**STAFF REPORT 06-26-2019 MEETING**

**APPLICATION NUMBER: 19-6300**

**ADDRESS: 2221 WABASH**

**HISTORIC DISTRICT: CORKTOWN**

1 EAST ELEVATION  
A1.1 SCALE: 1/4" = 1'-0"

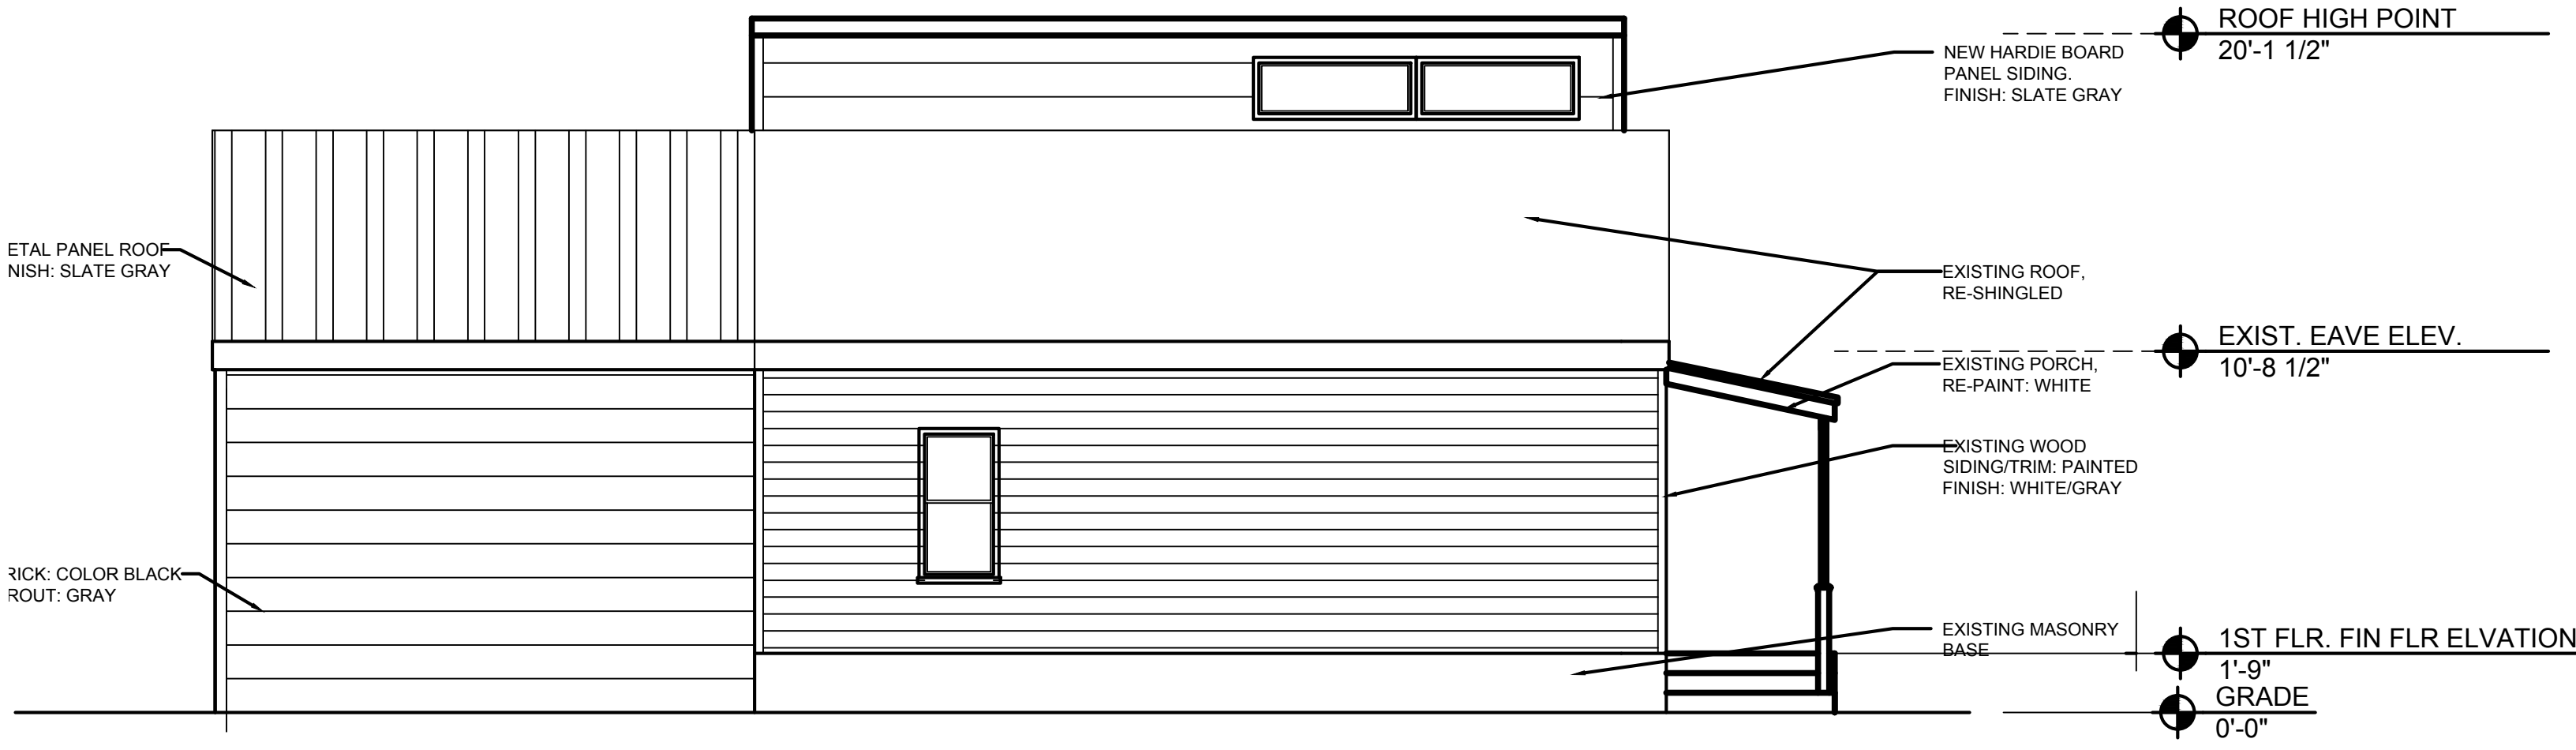
The front (east-facing) elevation of the new north addition is proposed to be brick punctuated with two 4/4 wood windows. The brick materiality of the addition is somewhat at odds with the more typical frame construction predominant for single-family homes in the district and specifically called out in the Elements of Design, as well as inconsistent with the typical relationship between historic dwellings and additions in Detroit (i.e., brick is rarely used in additions to frame houses, with the notable exception of commercial storefront additions built towards the street in front of older frame houses in the pre-war era). Typical residential additions were finished in siding, panels, or stucco. The brick is proposed to be gray or black, which, along with the small setback in plane, will recede in deference to the historic core. Note that there are several multi-family brick buildings in the district, including nearby on Wabash.

The proposed addition adds reasonable space to the area of a very small house while clearly delineating the historic core and preserving historic materials that characterize the property. Remaining original features and finishes, including the nineteenth-century clapboard siding and trim, are proposed to be preserved and repaired. While the proposed north side addition, especially, is very contemporary, the sloped roof, projecting eaves, and other gestures are generally in keeping with the district context and elements of design, and are deferential while remaining distinct, serving almost as a visual bracket. Staff therefore recommends that the Commission approve the proposed demolition, additions, and exterior alterations, as the proposed changes appear to be appropriate per Secretary of the Interior Standards 5, 9, and 10; however, staff does recommend a condition that the use of brick on the addition be reduced to the foundation only.
